Addendum No.: 4

Date Of Addendum: March 9, 2021

Ella T. Grasso Technical High School  
189 Fort Hill Road  
Groton, Connecticut  
Project BI-RT-877A  
BI-RT-877A, OSCGR PROJECT NO: 900-0014

PROJECT NO.:  
SK SB-1 C4.0-1

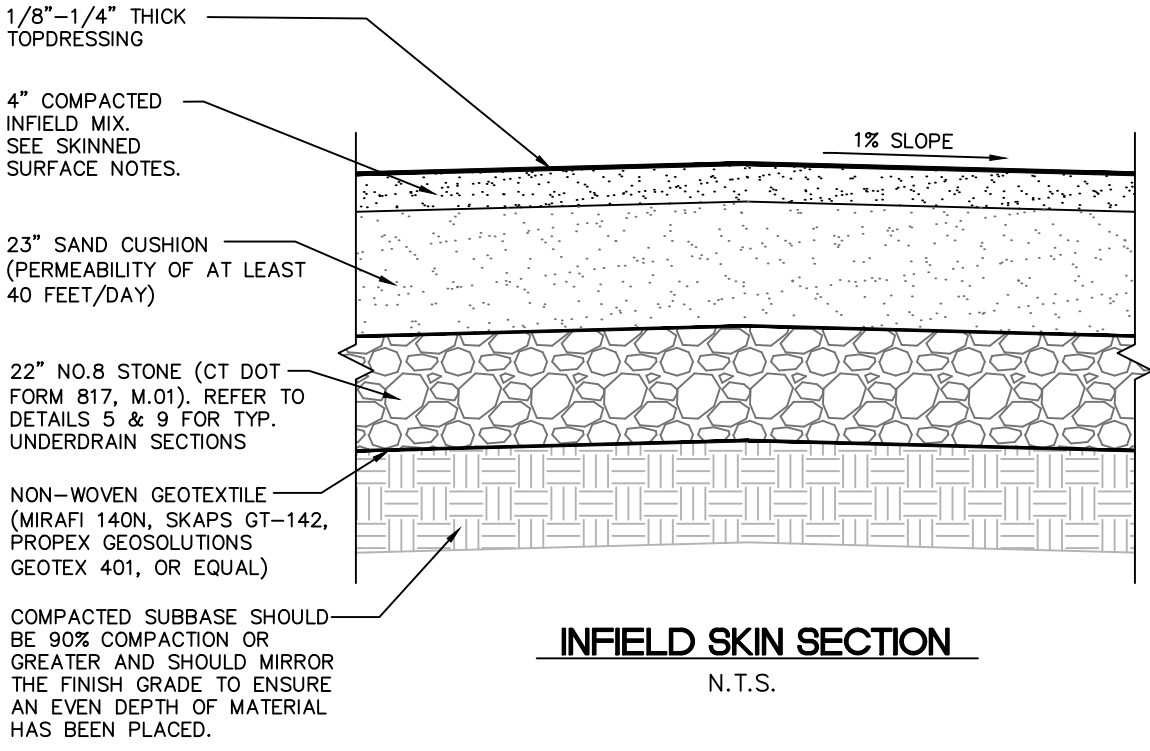
**ITEM 23:** The plans for the lower fields provide a detail on SB-1 C4.0 for warning track at 4" thick "stone dust", this does not show geotextile or subbase, This conflicts with the spec section 32 18 21 that calls for 4" of subbase, geotextile and 3" of stone dust after compaction. Please verify which we are to use for bidding. The plan detail or the specs?

**ITEM 26:** Please confirm if the sand layer extends under the warning track.

**RESPONSE (23): Refer to provided SK SB-1 C4.0-1 to replace "Warning Track Section" on Drawing SB-1 C4.0 as part of this addendum.**

**RESPONSE (26): Refer to provided SK SB-1 C4.0-1 to replace "Warning Track Section" on Drawing SB-1 C4.0., transmitted with this Addendum Four.**

SK SB-1 C2.0-1

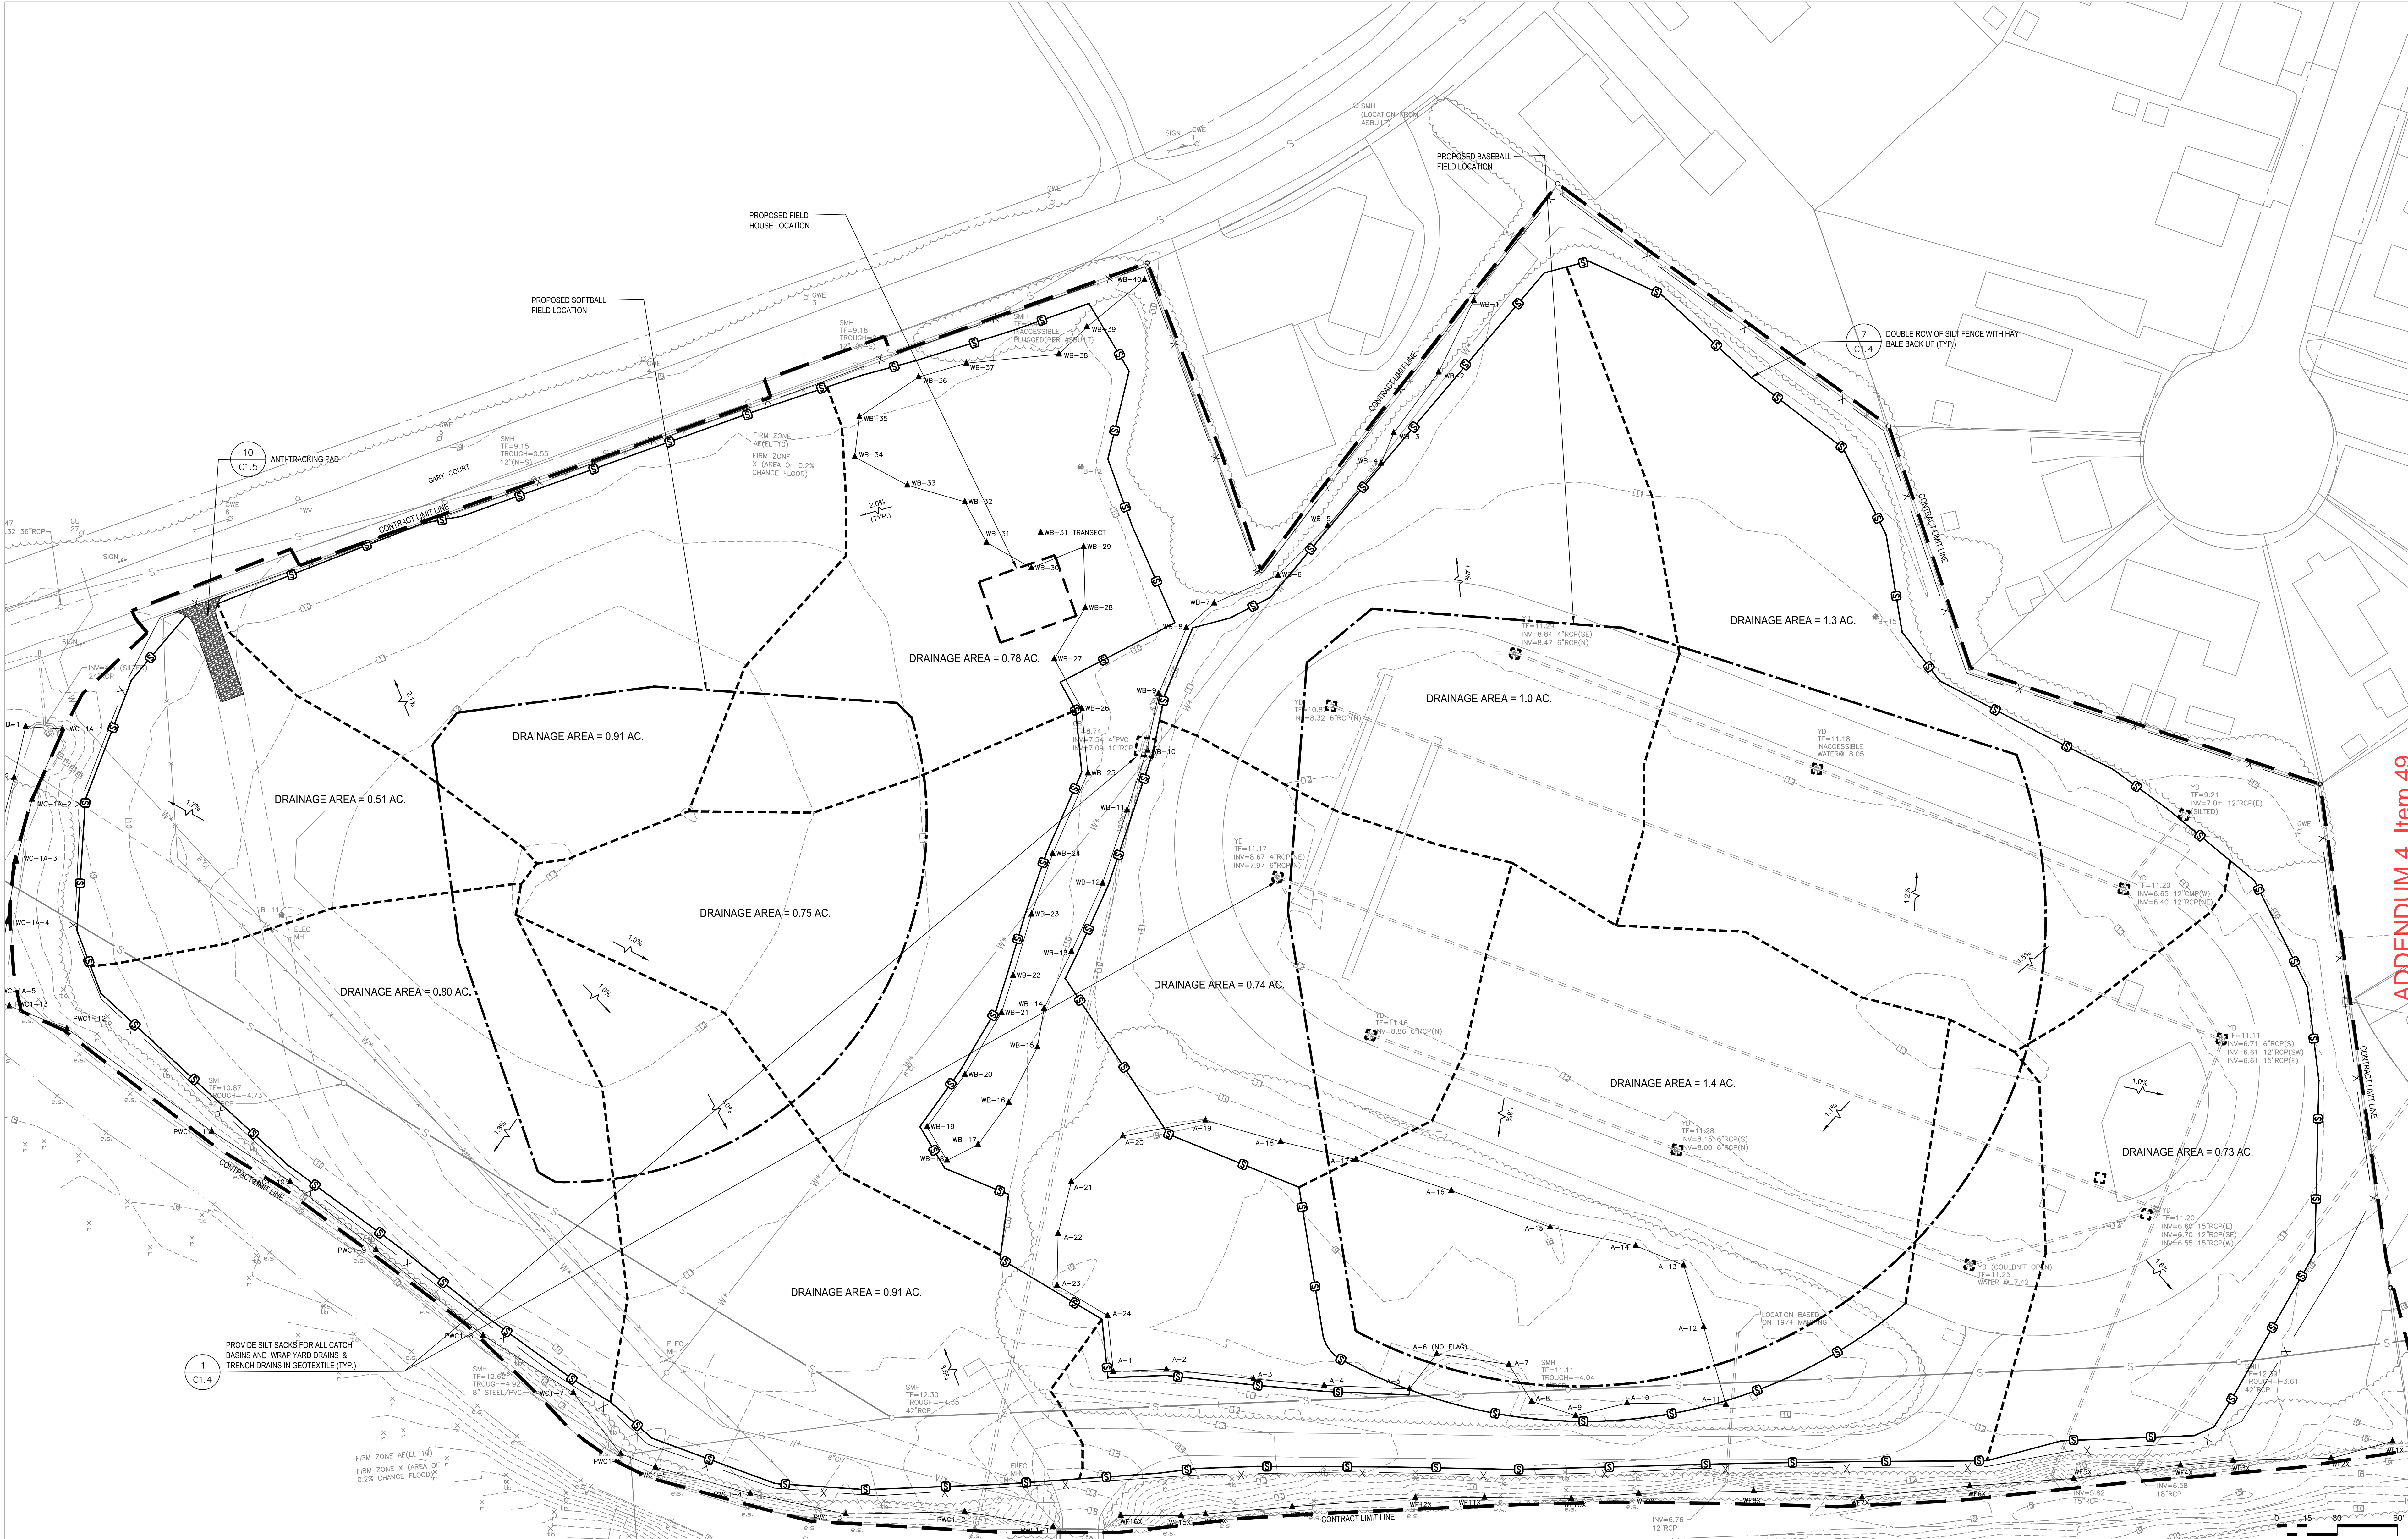
**ITEM 28:** The concrete sidewalk enlargement shows detectable warning pavers along the South & West sides of the field house. The site plan shows neither detectable warning pavers nor a concrete sidewalk along the West side of the building. Please advise as to where the detectable pavers should be located as well as what the layout for concrete sidewalk around the field house is.

**RESPONSE (28): REPLACE the "Concrete Walk Enlargement", detail 1 on drawing C2.0 with sketch SK SB-1 C2.0-1 included in this addendum.**

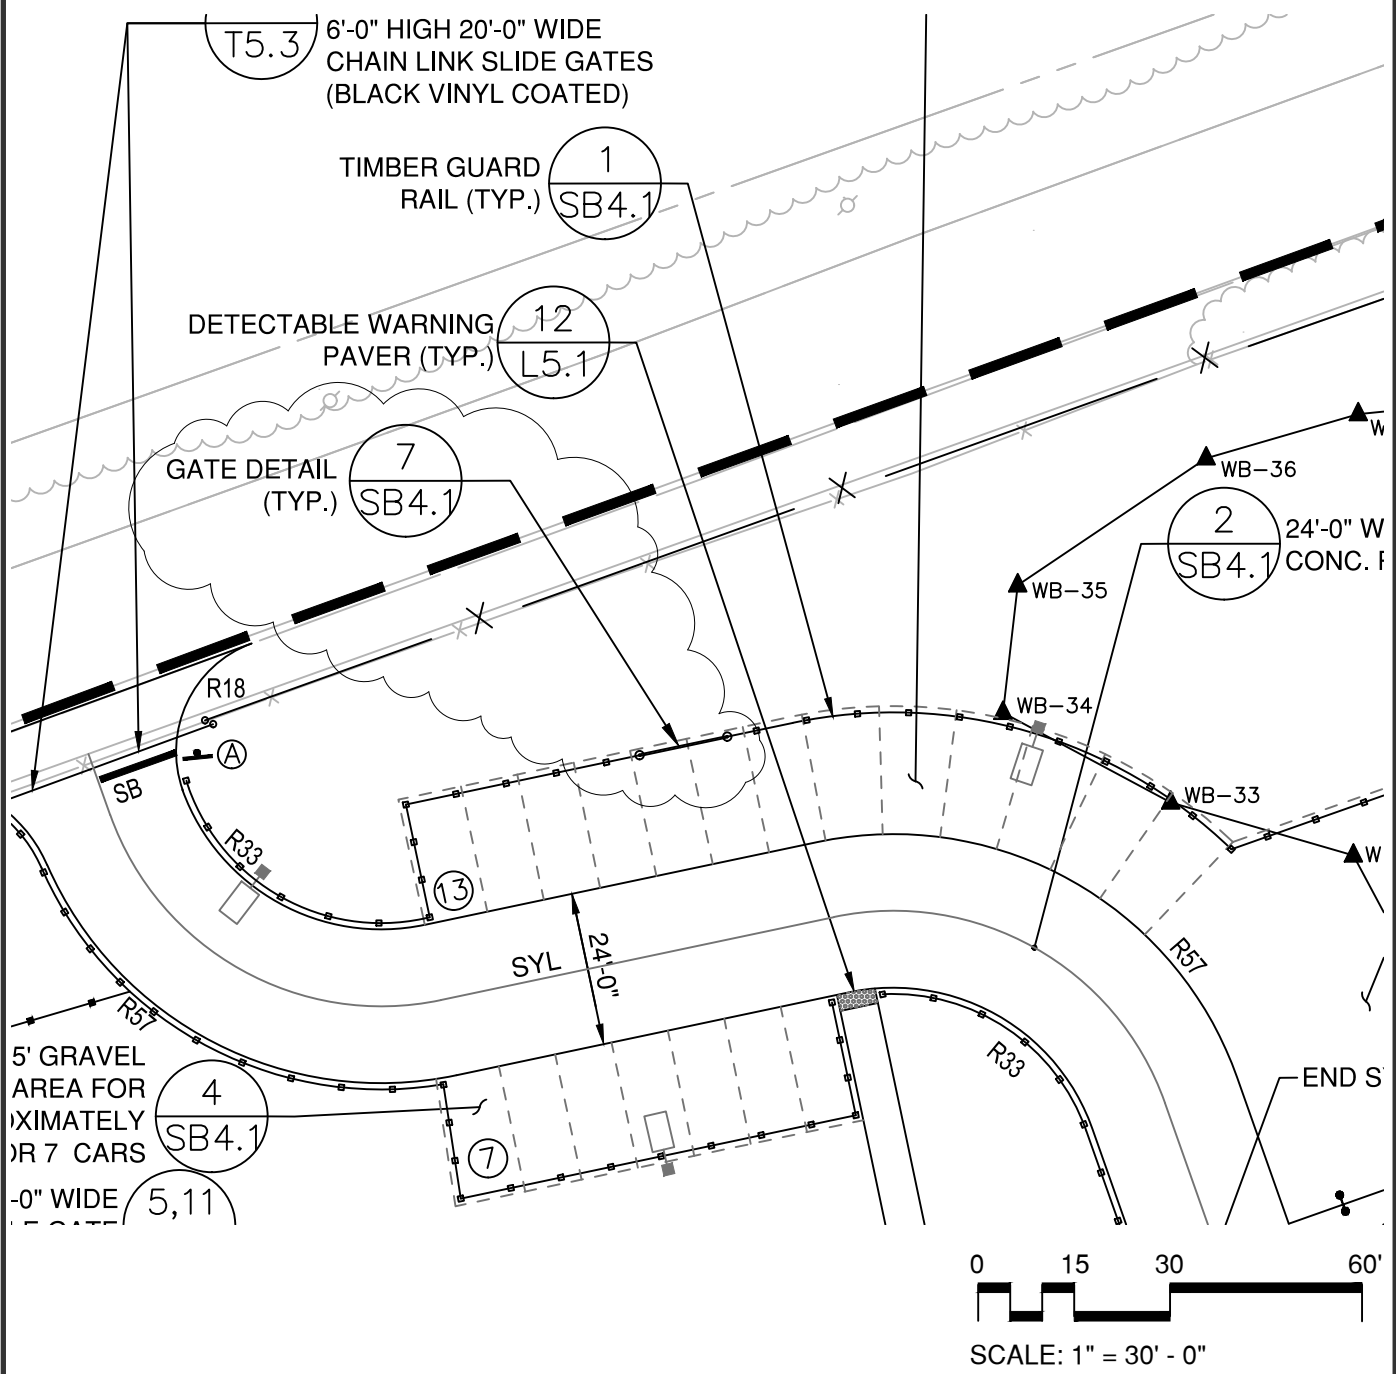
**ITEM 49:** Drawing Sheet noted as omitted in error from Bid Documents

**INSERT Sheet SB1-C1.0, Storm Water Pollution and Control Plan (SWPCP) transmitted with this Addendum Four**
